AMENDMENT NO. 2 AUGUST 2017
TO
IS 13702 : 1993 PROPYLENE GLYCOL, FOOD GRADE — SPECIFICATION

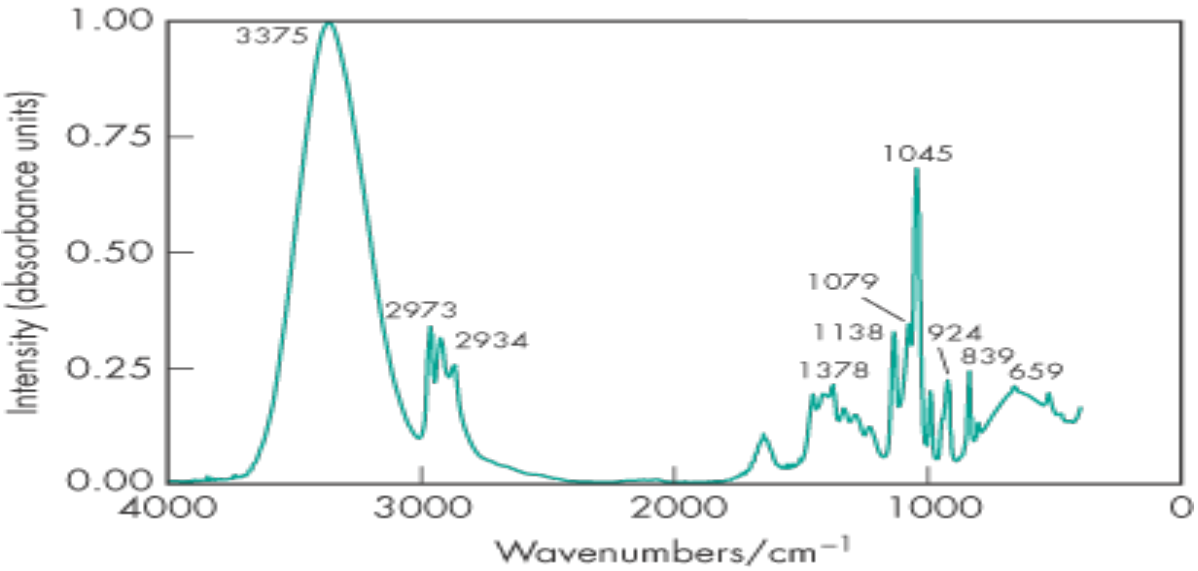
(*Page* 1, *clause* **3.2.2**) — Insert the following new clause at the end:

'**3.2.3** The infrared spectrum of a potassium bromide dispersion of the sample corresponds with the infrared spectrum below:
